Docket Number:	22-BSTD-02
Project Title:	2022 Energy Code Compliance Software & Supporting Documents
TN #:	249501
Document Title:	IES VE T24 2022 1_0 Sensitivity Tests Narrative
Description:	N/A
Filer:	RJ Wichert
Organization:	California Energy Commission
Submitter Role:	Commission Staff
Submission Date:	3/30/2023 12:46:15 PM
Docketed Date:	3/30/2023

Narrative for IES VE Title 24 2022.1.0 Sensitivity Tests

Figure 1: IESVE TES loop and ChWL

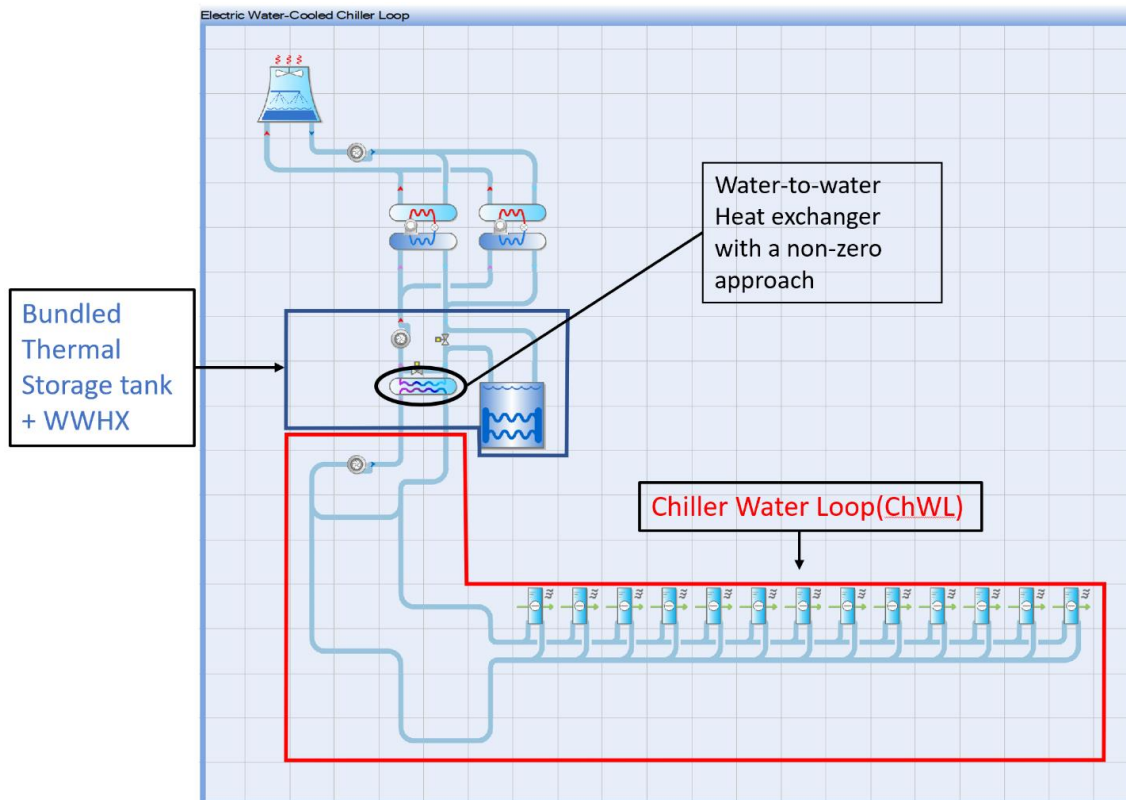
- CEC Comment: Higher TDV Energy in the TES model than the Baserun model.

The TES model in IESVE has a Water-to-water heat exchanger (WWHX) that transfers heat between the TES loop and the ChWL (see Figure 1 below). This heat exchanger is permanently coupled with the TES tank to avoid any potential mixing of water/glycol with water only; thus maintaining the heat transfer properties of water in the Chilled Water Loop. The WWHX has a non-zero approach temperature. i.e., there will always be a temperature drop in the WWHX. To account for this temperature drop, when the chiller is cooling the building, the chiller leaving water temperature needs to be lower than the required ChWL supply temperature (44°F) because it must first overcome the inefficiency of the WWHX.

However, the baseline model (400006) does not have a WWHX. As a result, the chiller water leaving temperature is 44°F.

Since the chillers in the TES model has to cool the water to a lower temperature (to account for the temperature drop in the WWHX) the chillers consume more energy than the baseline chiller. This has therefore been reflected in the TDV of the model. Figures below show the TDV of the baseline chiller
